Groundwater Application Review Summary Form

Application # G- 18594

TO: Water Rights Section Date 08/30/2018
 FROM: Groundwater Section Darrick E. Boschmann
Reviewer's Name
 SUBJECT: Application G-18594 Supersedes review of N.A.
Date of Review(s)

A. GENERAL INFORMATION: Applicant's Name: Surprise Valley Electrification Corp County: Lake

Figure 2: Hydrograph for LAKE 1633.

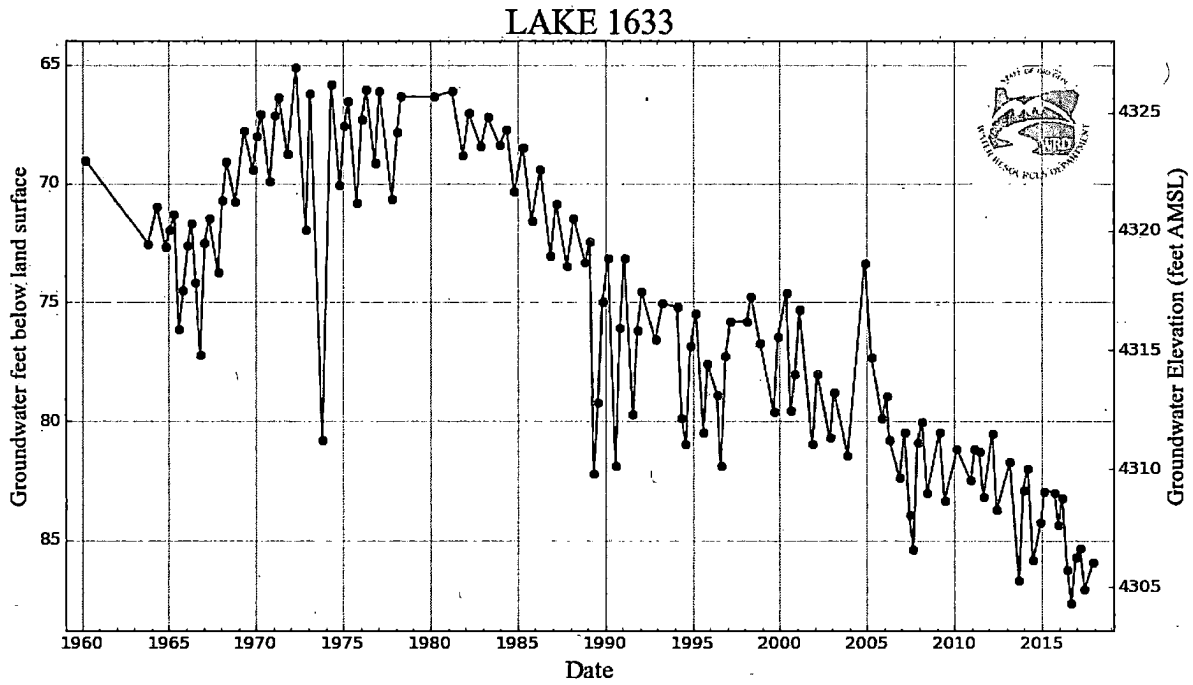
The nearest state observation well to the proposed location is State Observation Well 374 (LAKE 1633) located ~1.5 miles to the northeast which has a period of record from 1963 to 2017. The long term annual groundwater level trend in this well indicates an overall year-year water level decline of about 19 feet from 1980 to 2017, or roughly 0.5 feet per year since 1980. Formation descriptions on the well log for LAKE 1633 indicate the well is completed in the basin fill sediments.

Figure 3: Reported permit condition water level data for LAKE 52683.

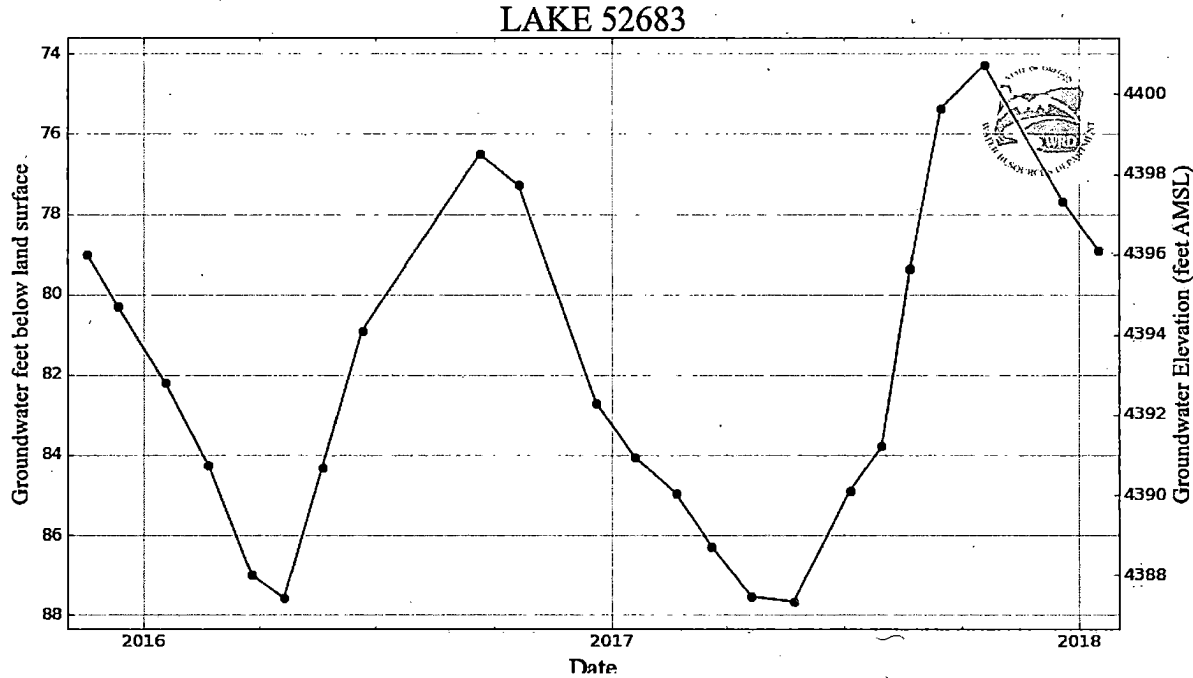
Observation well LAKE 52683 (permit condition obs well under permit G-17434; 380ft TD/115°F) located within the project area has a period of record from 2015 to 2018. No long term annual groundwater level trend can be identified in this well due to the short period of record; however there are no immediate signs of water level decline. Formation descriptions on the well log for LAKE 52683 indicate the well is completed in the basin fill sediments.

Figure 4: Reported permit condition water level data for LAKE 1628.

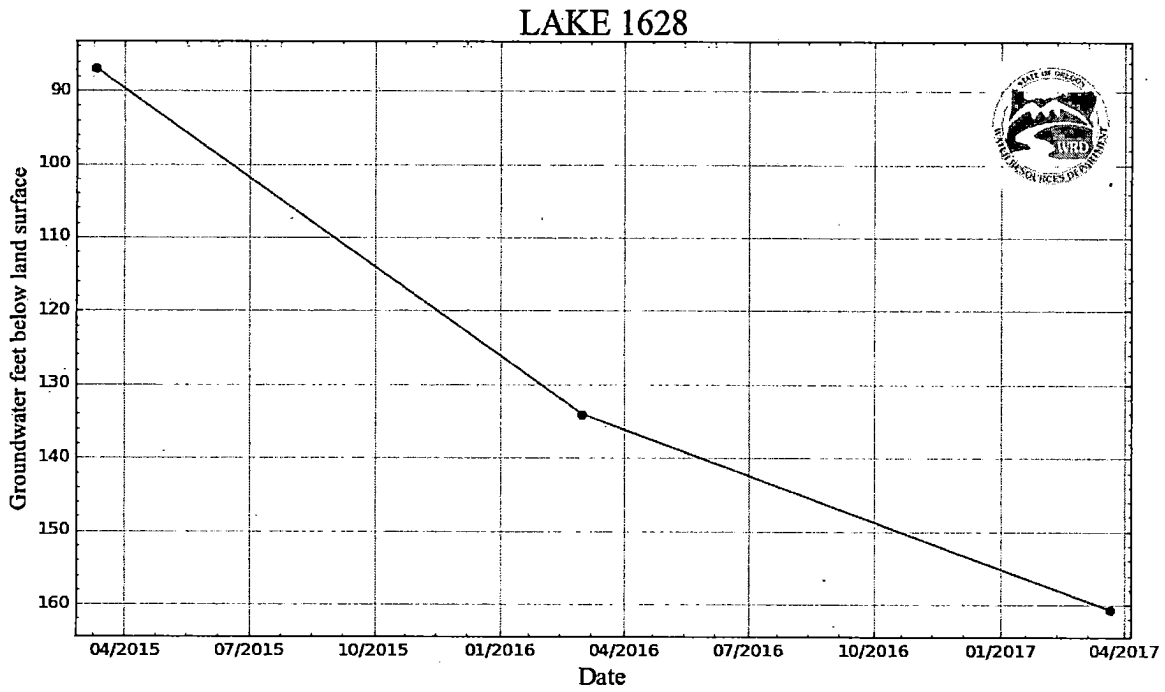
March static water levels reported to the department under the permit condition program for LAKE 1628 (“Little Hot Well”; 432 ft TD/175°F) indicate a 73 foot water level decline over the period 3/2015 – 30/2017. March static water levels reported to the department under the permit condition program for LAKE 52506 (“SVE#4” industrial use/cooling water; 378 ft

It is clear from the supplemental data that the “static” water level reported to the department for 03/01/2016 and 03/22/2017 for LAKE 1628 was affected by a recent period of pumping either in that well, or in LAKE 52506, or possibly both, and that the water level reported represents a pumping or recovery/rising level, rather than a true static water level which could be directly compared to the March level from the previous year. Due to the year-round pumping/recovery cycles at this well it is difficult to determine whether or not any year-to-year water level declines are occurring, however since regular pumping began in 2015 the well has never fully recovered to its pre-2015 static water levels, and the full record does seem to indicate that declines may be occurring.

Figure 5: Reported permit condition water level data for LAKE 52506.

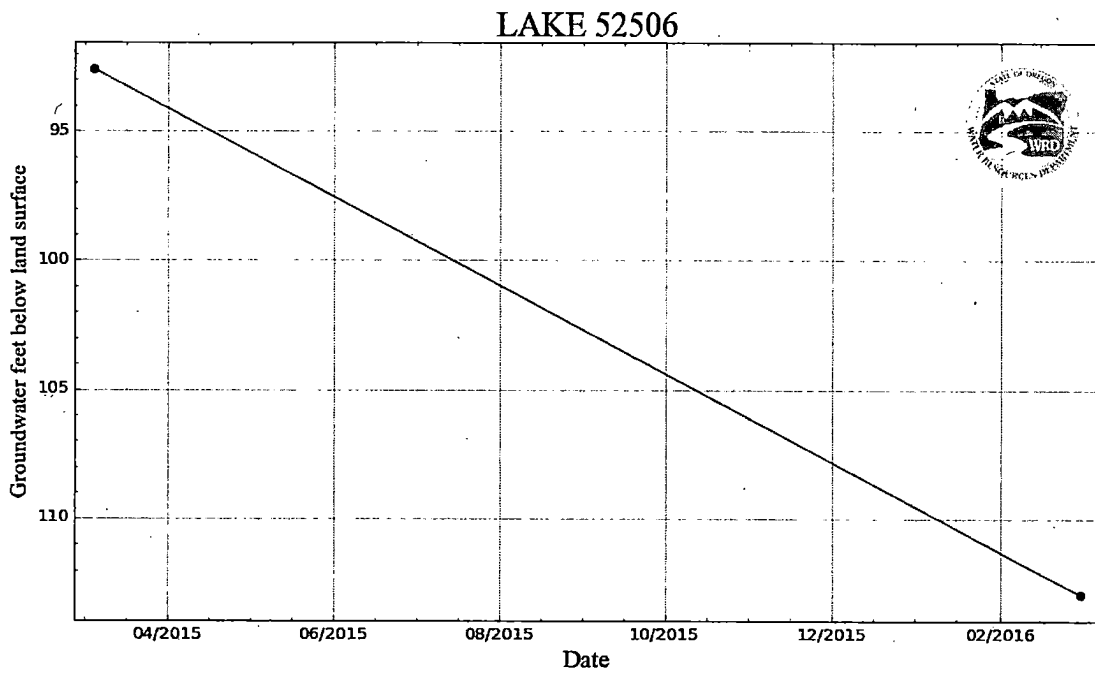
TD/118°F) indicate a 20 foot water level decline over the period 3/2015 – 3/2016. These reported records suggest significant rates of decline in the immediate vicinity of proposed production well LAKE 52529 (see following paragraphs).

It is clear from the supplemental data that the “static” water level reported to the department for 03/01/2016 for LAKE 52506 was affected by a recent period of pumping in that well; and that the water level reported represents a pumping or recovery/rising level, rather than a true static water level which could be directly compared to the March level from the previous year. The period of record for LAKE 52506 provided in the supplemental data covers 05/12/2014 – 01/16/2018. Due to the year-round pumping/recovery cycles at this well it is difficult to determine whether or not any year-to-year water level declines are occurring; although from October 2014 to October 2017 (two periods for which there appears to be no direct pumping influence), the record does indicate approximately 7-8 feet of overall decline; or approximately 2.5 ft/yr.

Figure 8: Supplemental data provided by the applicant - LAKE 52530.

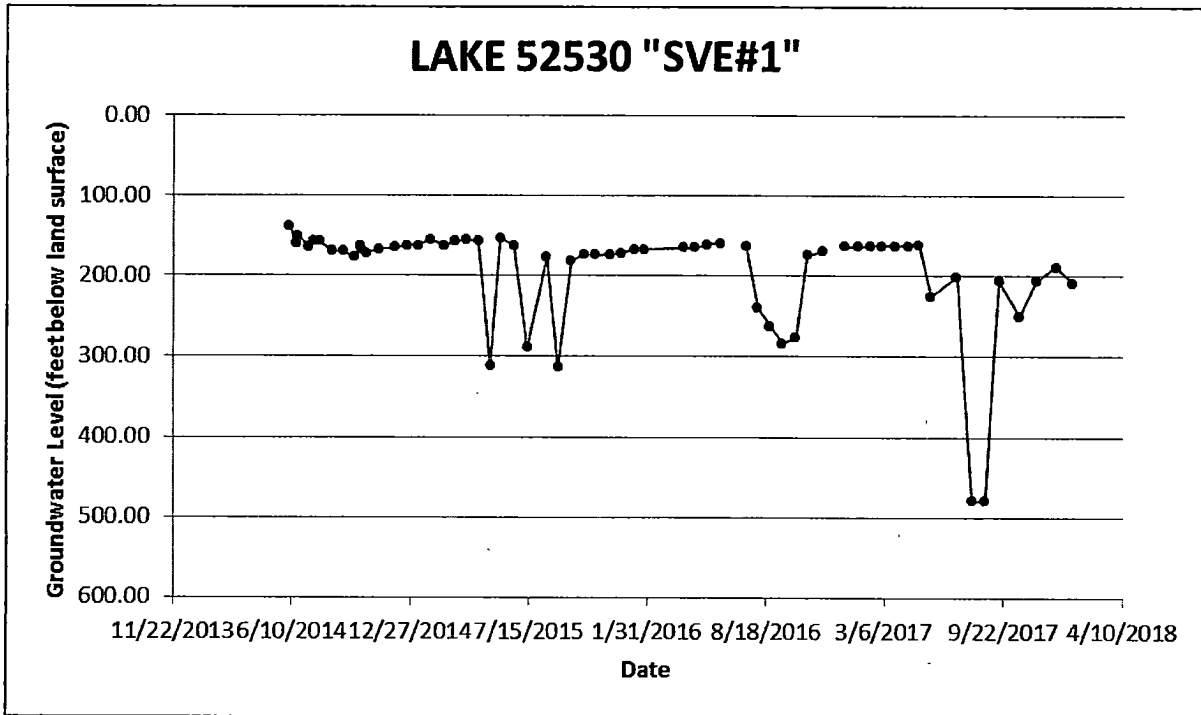
Proposed production well LAKE 52530 (SVE#1) has a period of record from 6/6/2014 to 1/16/2018. Due to the year-round pumping/recovery cycles at this well it is difficult to determine whether or not any year-to-year water level declines are occurring, however there are no apparent signs of significant water level declines.

Figure 9: Supplemental data provided by the applicant - LAKE 52529.

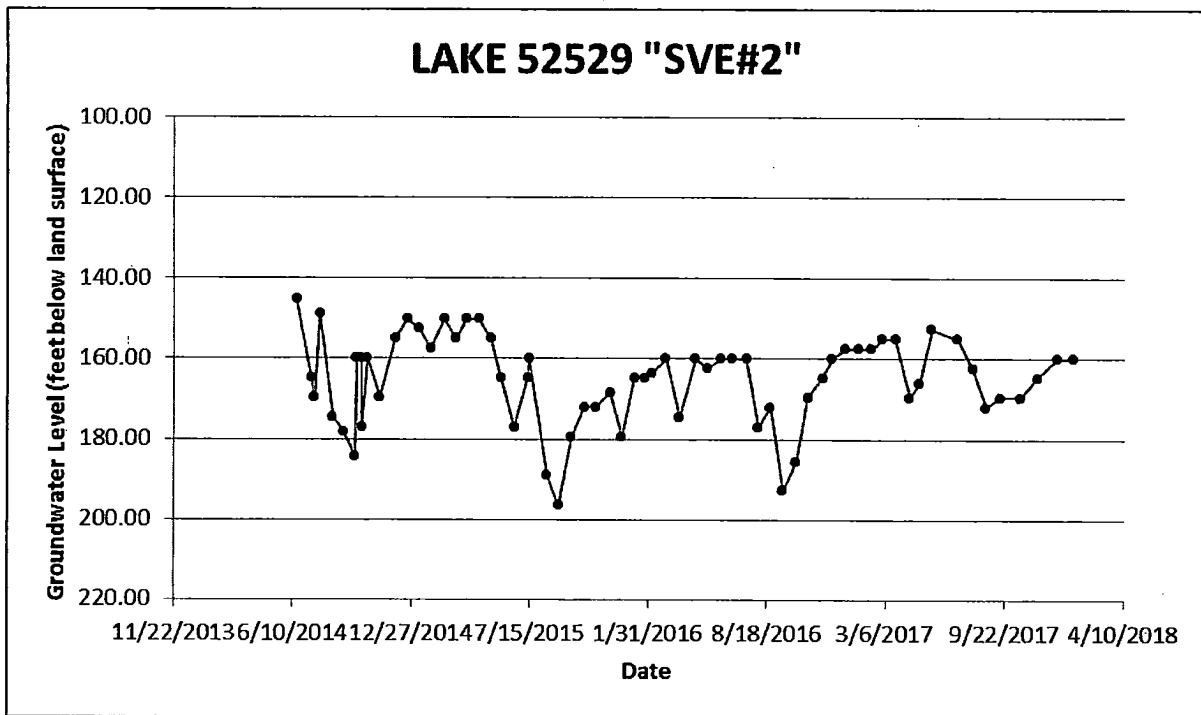
Proposed production well LAKE 52529 (SVE#2) has a period of record from 6/17/2014 to 1/16/2018. Due to the year-round pumping/recovery cycles at this well it is difficult to determine whether or not any year-to-year water level declines are occurring, however there are no apparent signs of significant water level declines.

Figure 10: Supplemental data provided by the applicant - LAKE 1638.

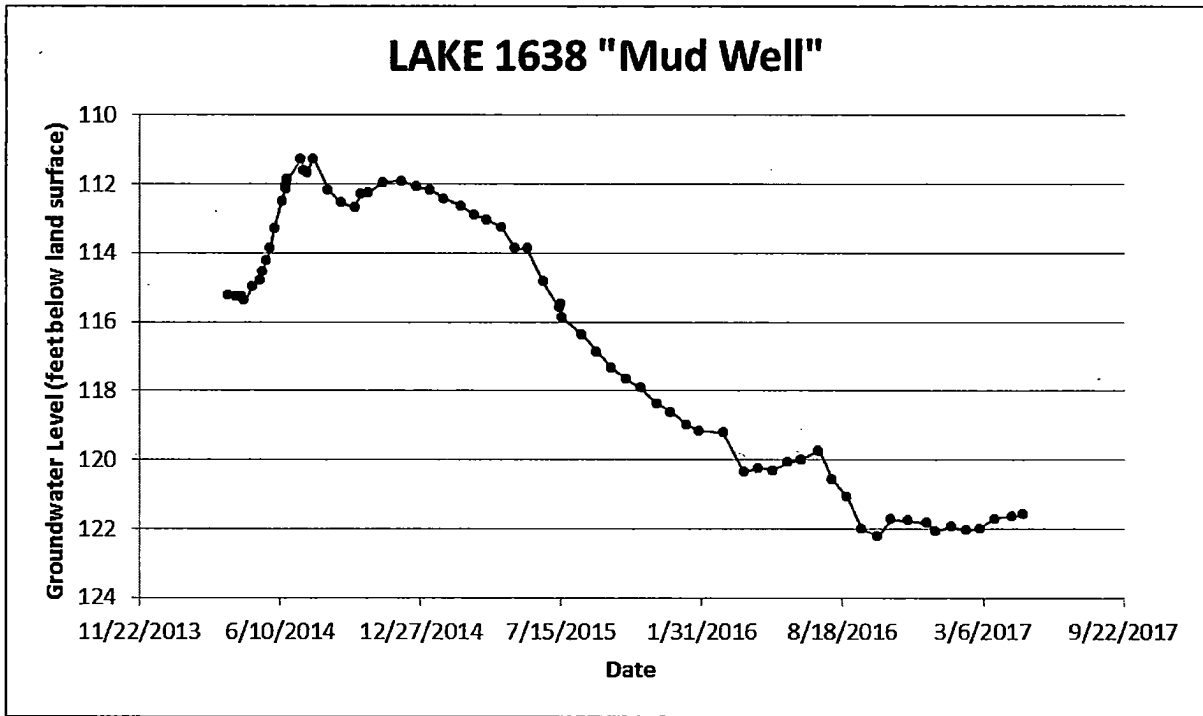
LAKE 1638 (“Mud Well”; unused irrigation well/livestock?; 775 ft TD/120°F) has a period of record from 3/28/2014 to 5/2/2017. The hydrograph for this reportedly unused irrigation well shows a clear and consistent decline trend from 2014 through spring of 2017 of approximately 6-10 feet over the period of record; or approximately 2 – 3.3 ft/yr. Formation descriptions on the well log for LAKE 1638 indicate the well is completed in the basin fill sediments.

Figure 11: Supplemental data provided by the applicant - LAKE 1625.

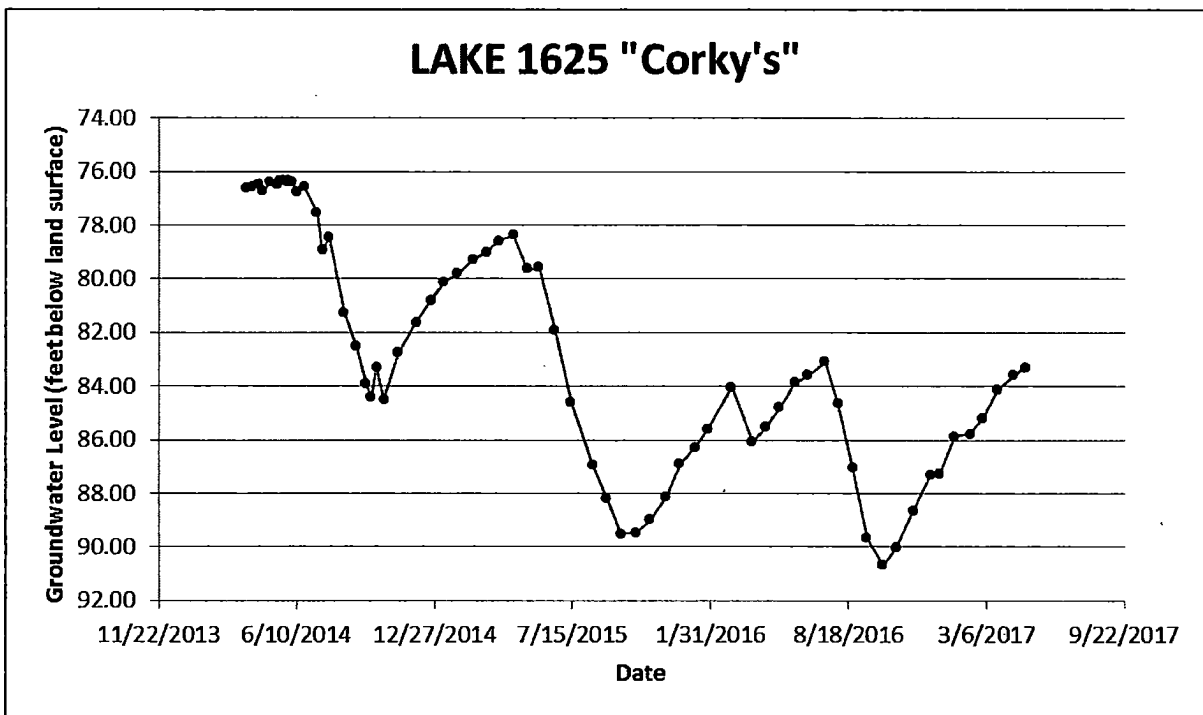
LAKE 1625 (“Corky’s”; unused irrigation well; 610 ft TD/175°F) has a period of record from 3/28/2014 to 5/2/2017. The hydrograph for this reportedly unused irrigation well shows a clear and consistent decline trend from 2014 through spring of 2017 of approximately 6-7 feet over the period of record; or approximately 2 ft/yr. Formation descriptions on the well log for LAKE 1625 indicate the well is completed in the basin fill sediments.

Figure 12: Supplemental data provided by the applicant - LAKE 1637.

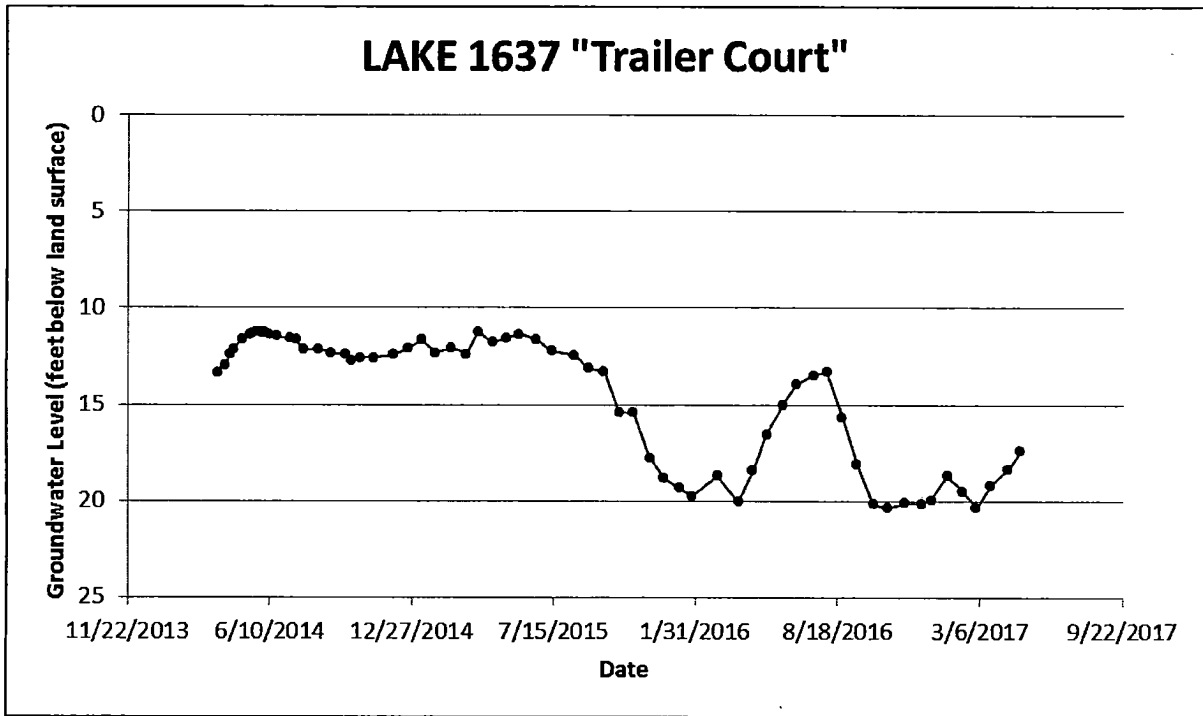
LAKE 1637 (“Trailer Court”; livestock; 153 ft TD/~75°F) has a period of record from 3/28/2014 to 5/2/2017. Due to the year-round pumping/recovery cycles at this well it is difficult to determine whether or not any year-to-year water level declines are occurring. Formation descriptions on the well log for LAKE 1637 indicate the well is completed in the volcanic rock unit.

Figure 13: Supplemental data provided by the applicant - LAKE 4278.

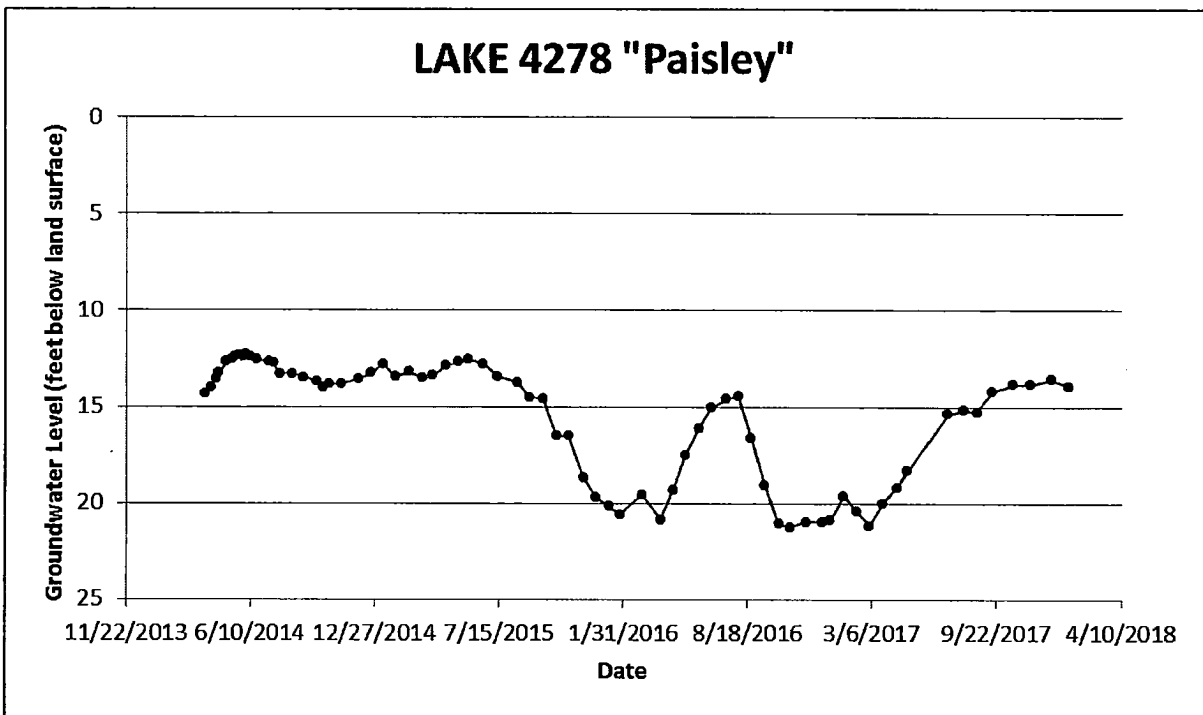
LAKE 4278 (“Paisley”; unused; 515 ft TD/115°F) has a period of record from 3/28/2014 to 1/16/2018. The hydrograph for this well does not indicate any apparent signs of significant water level declines. Formation descriptions on the well log for LAKE 4278 indicate the well is completed in the volcanic rock unit.

Figure 14: Supplemental data provided by the applicant - LAKE 51059.

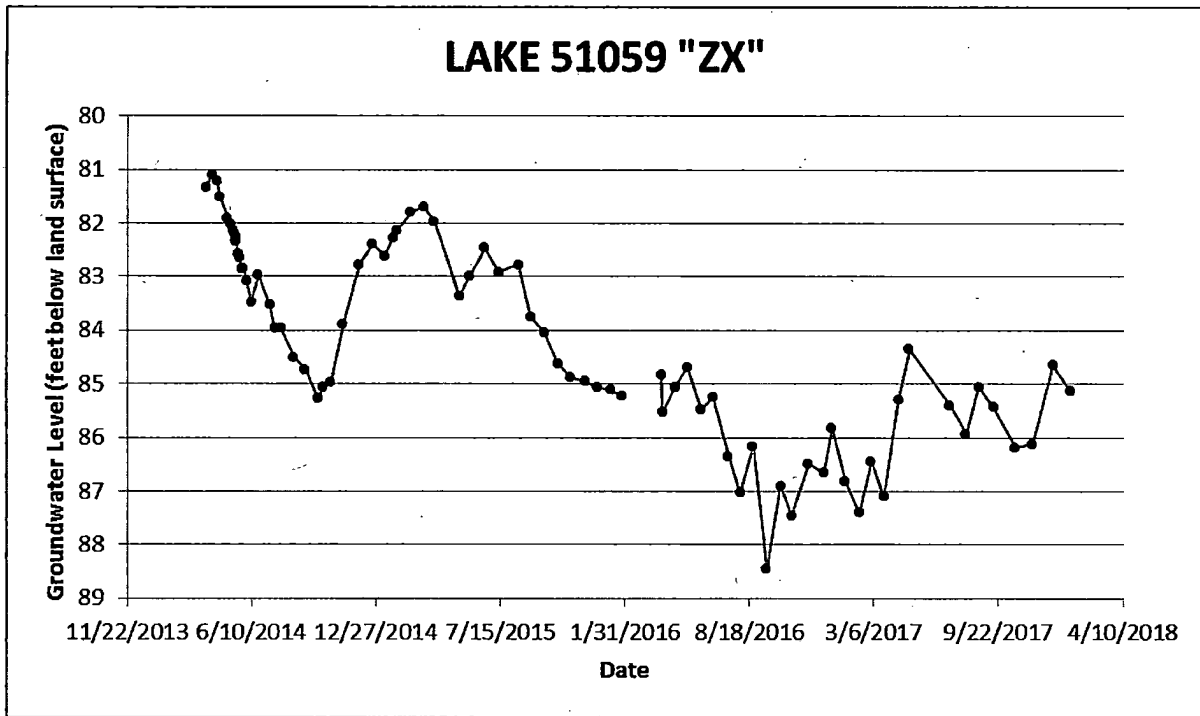
LAKE 51059 (“ZX”; unused; 1412 ft TD/78°F) has a period of record from 3/28/2014 to 1/16/2018. The hydrograph for this well indicates a decline trend from spring of 2014 through spring of 2017 of approximately 3.25 feet over the period of record; or approximately 1 ft/yr. Formation descriptions on the well log for LAKE 51059 indicate the well is completed in the volcanic rock unit.
